Lillian Schmitt Elementary – Bid Package #2

Addendum #2

March 15, 2024

DRAWING NUMBER
C000

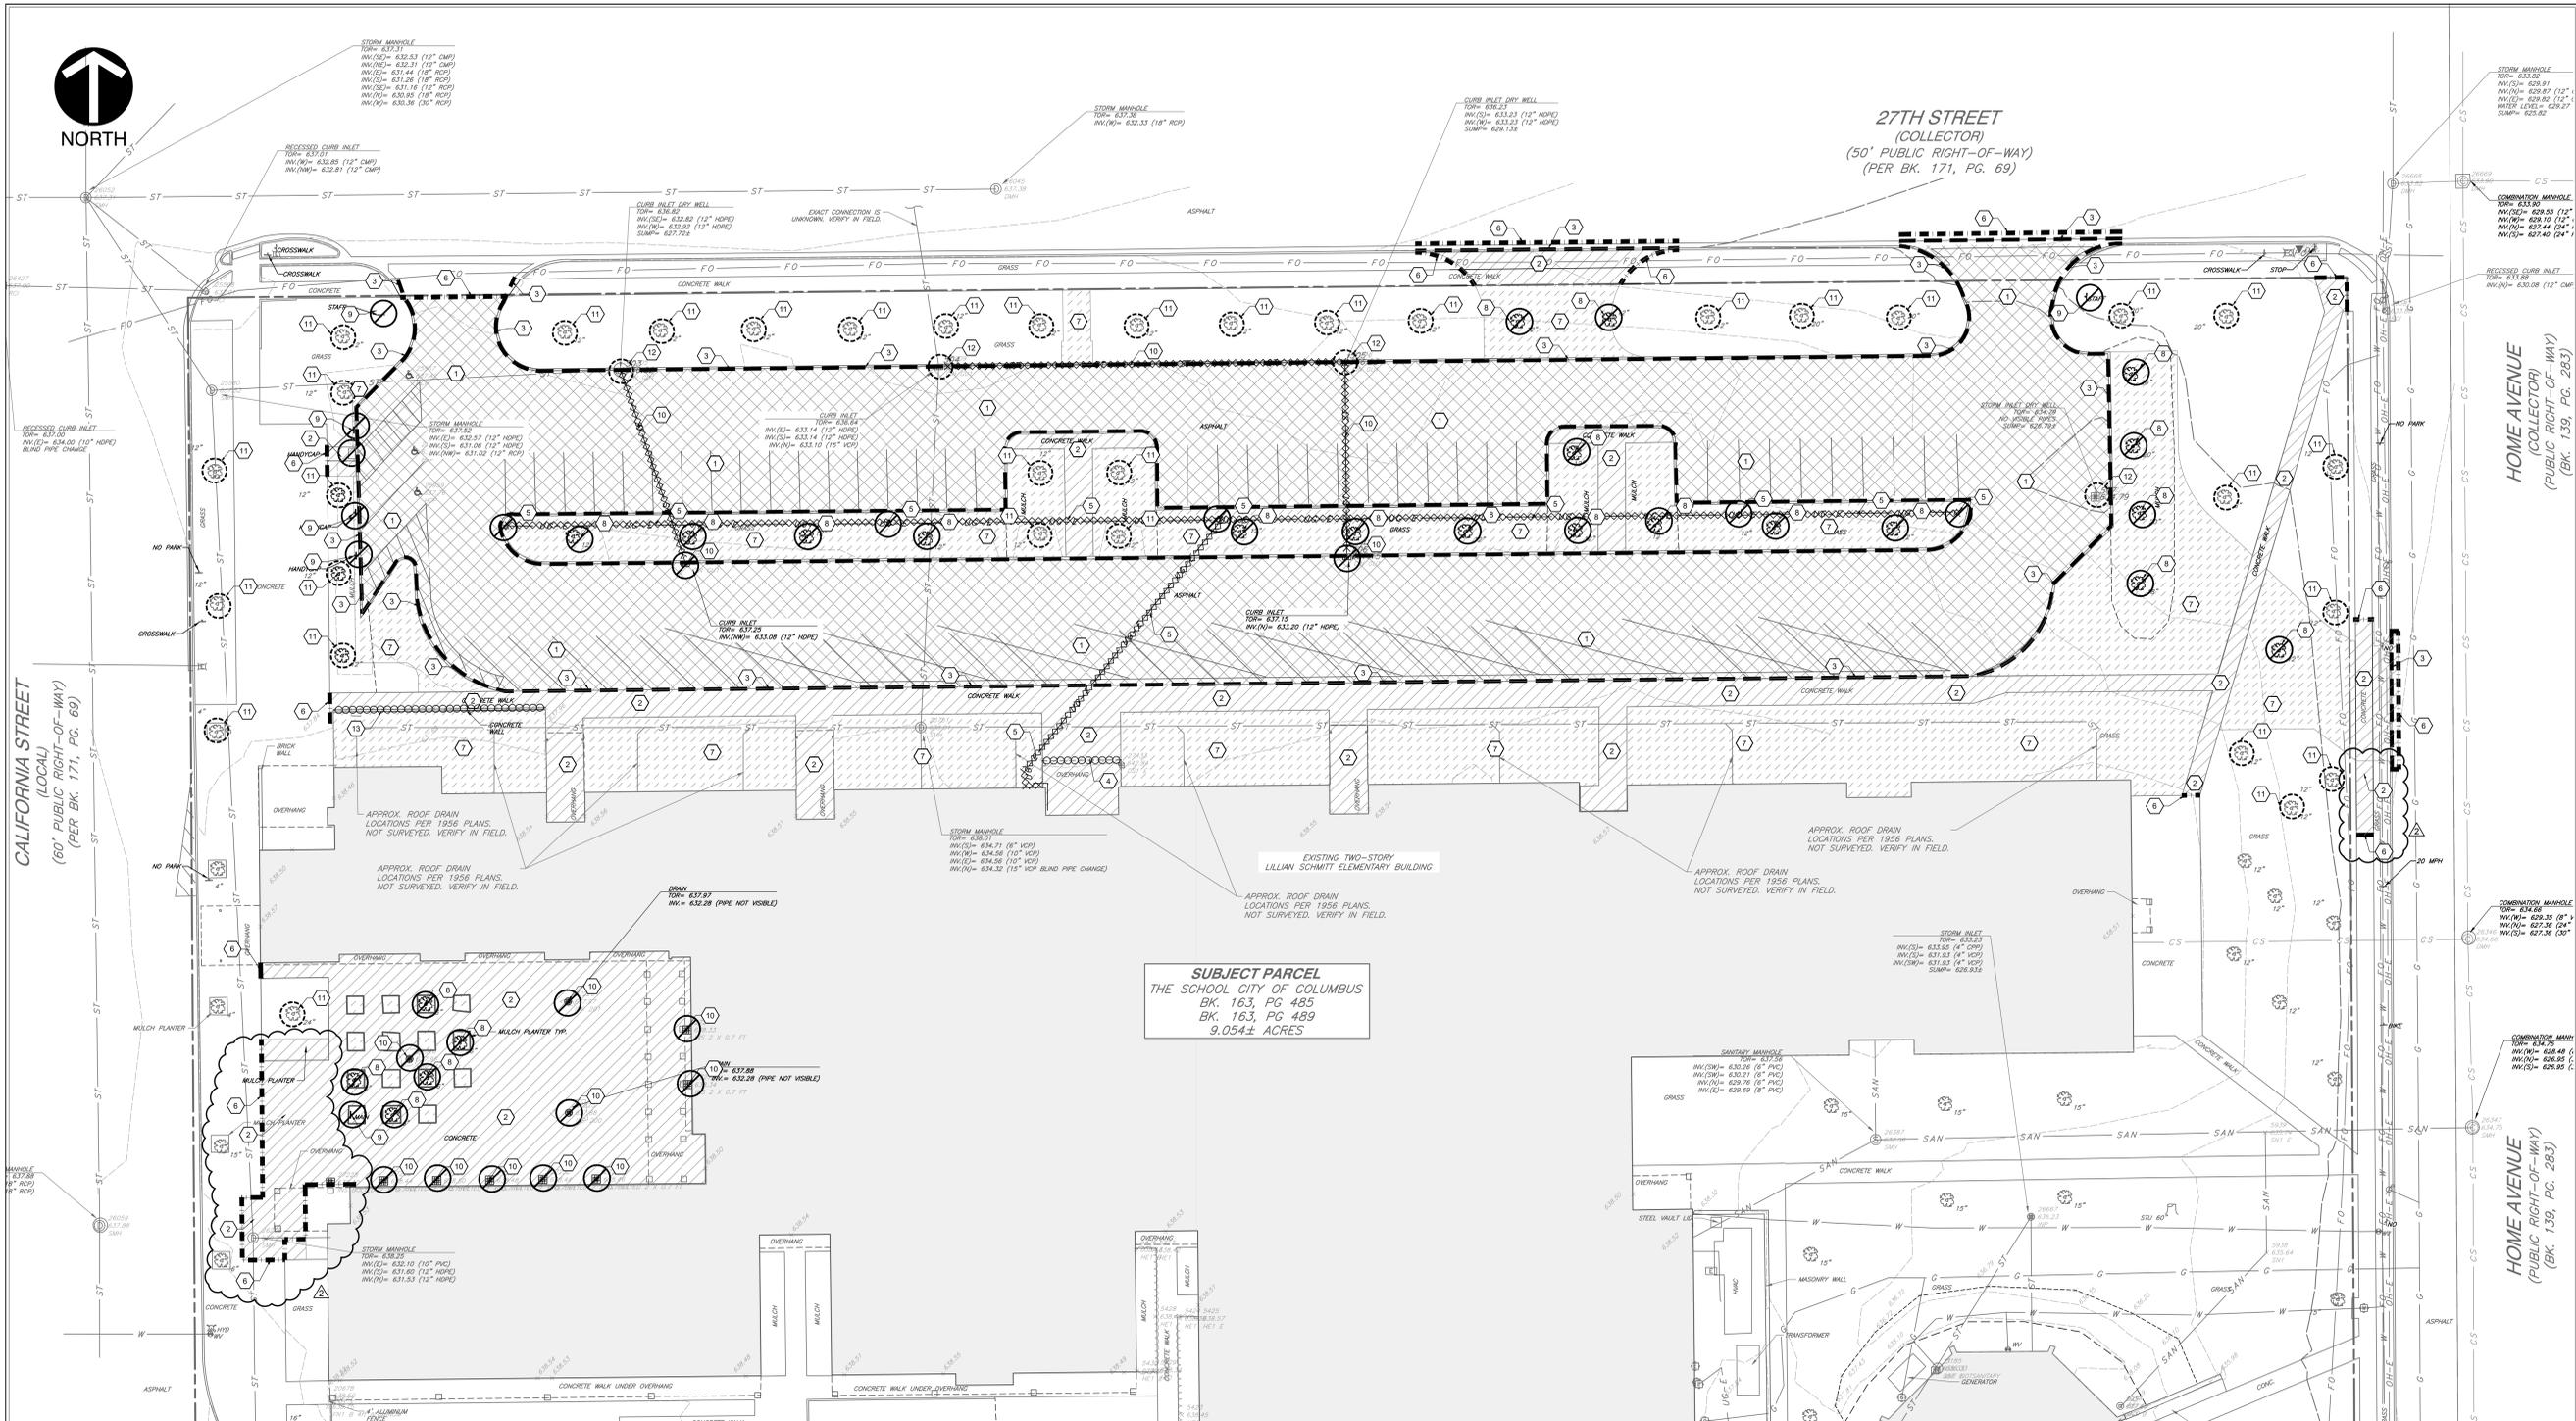
A. Modify drawing index to identify the revised sheets & dates under this addendum.

DRAWING NUMBER:
 C302

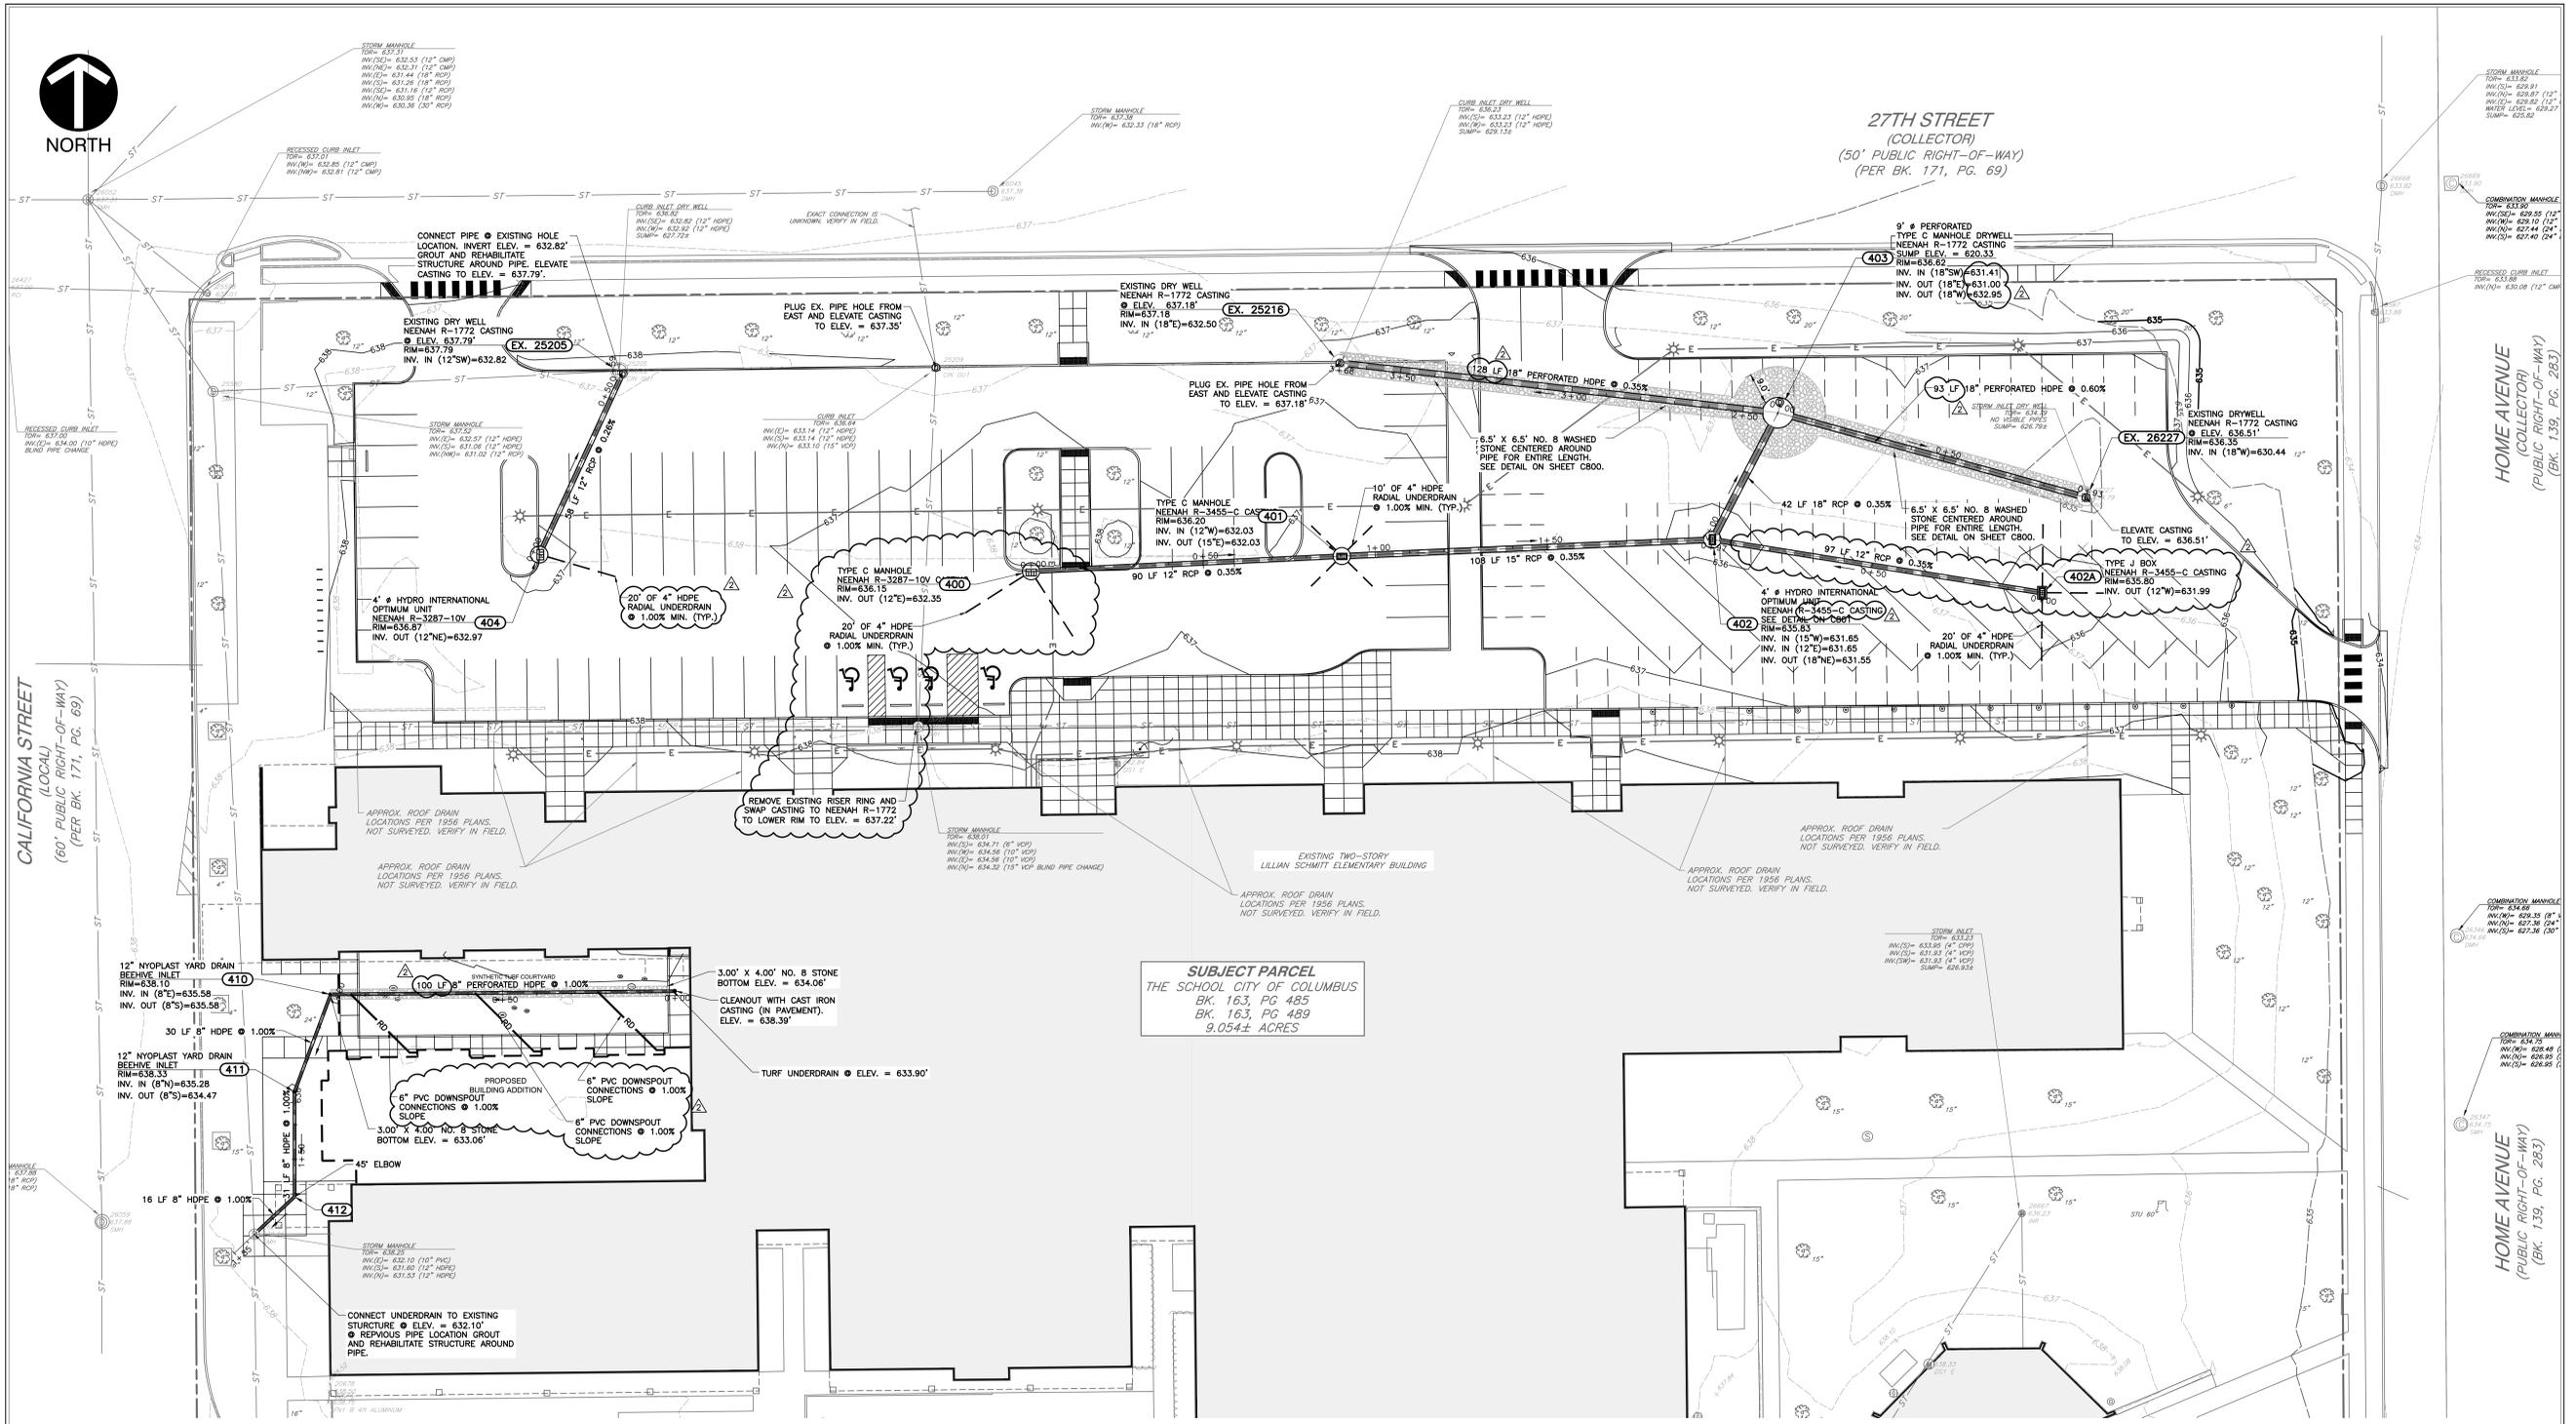
- F. Add grade elevations for light poles around south drive widening.

STR 402 - 402A PROFILE
SCALE: H:1"=20'; V:1"=4'

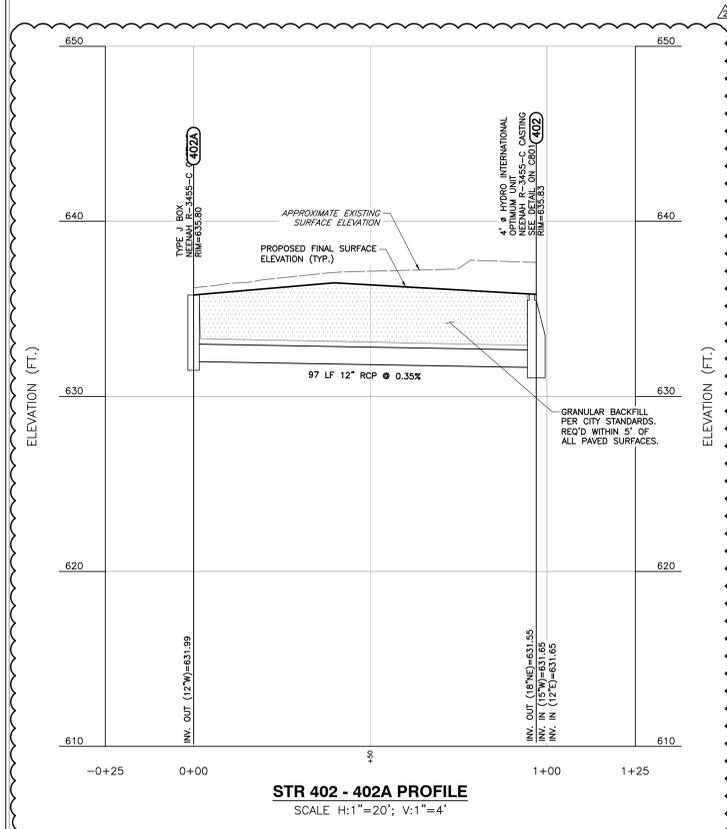
- N. Add profile for STR 402 – 402A (newly added inlet).

DRAWING NUMBER
C501
PROJECT NUMBER
2021049

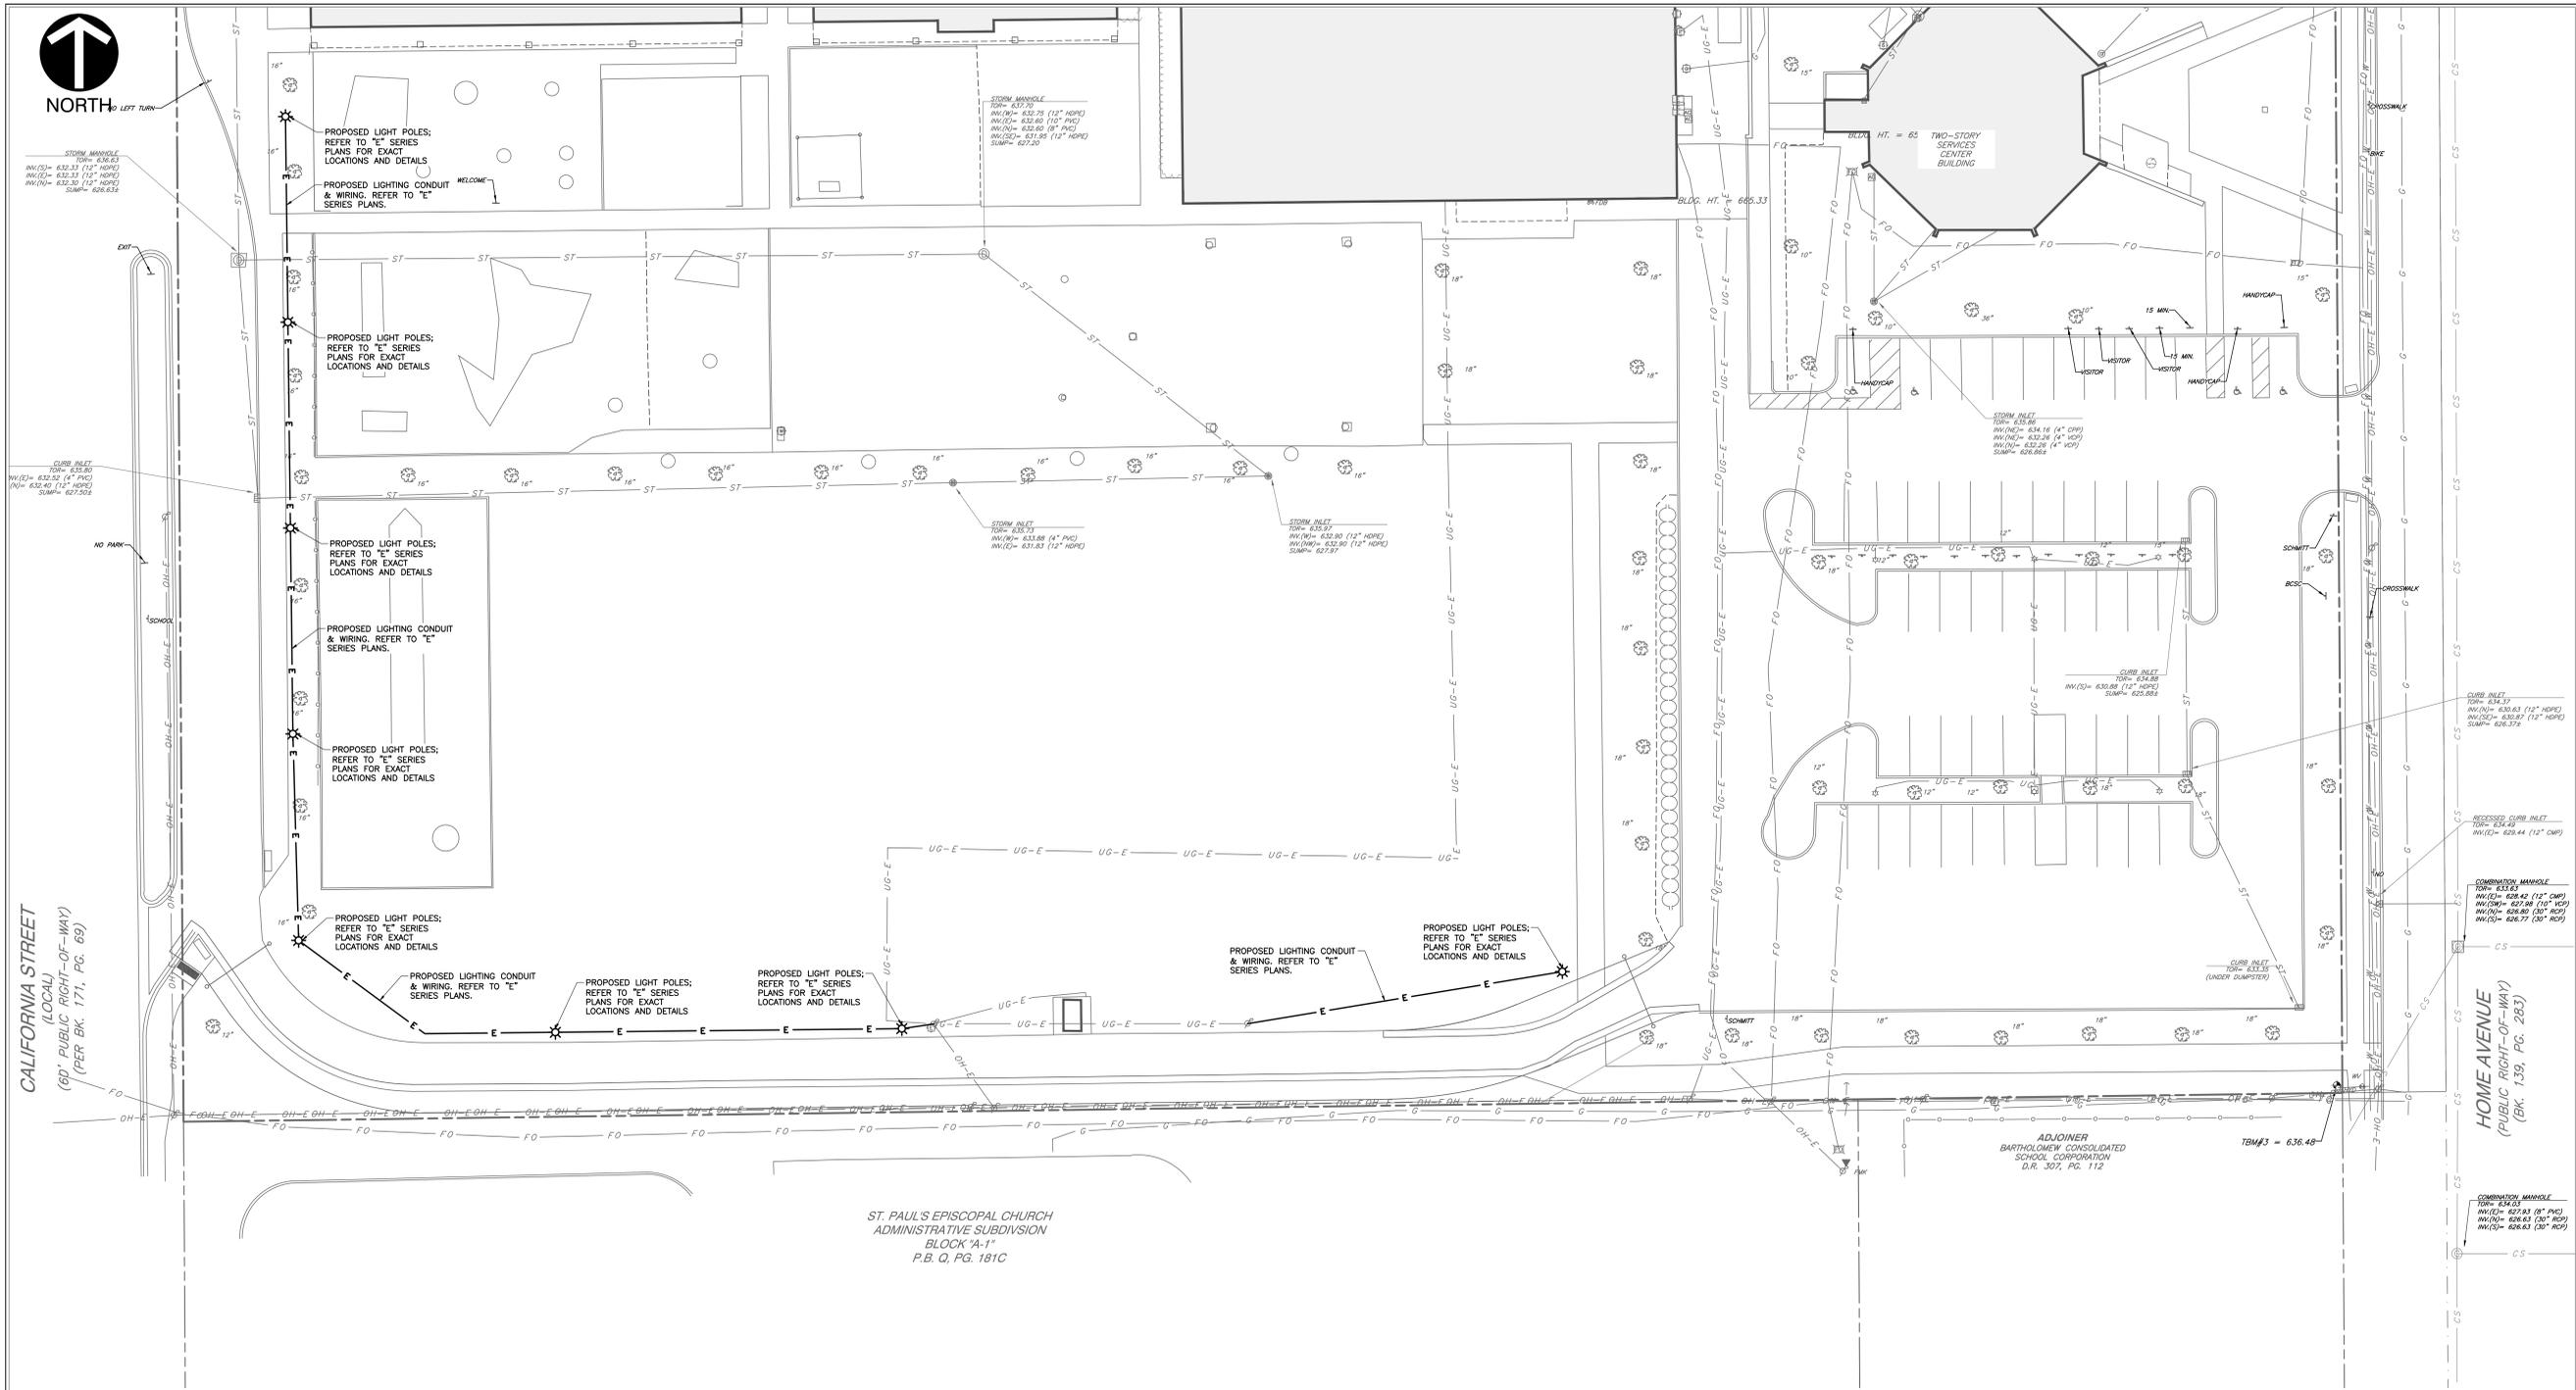
- P. Add sheet to show light pole locations corresponding with site lighting plan. Refer to E series of sheets for all specifics on lighting design information.
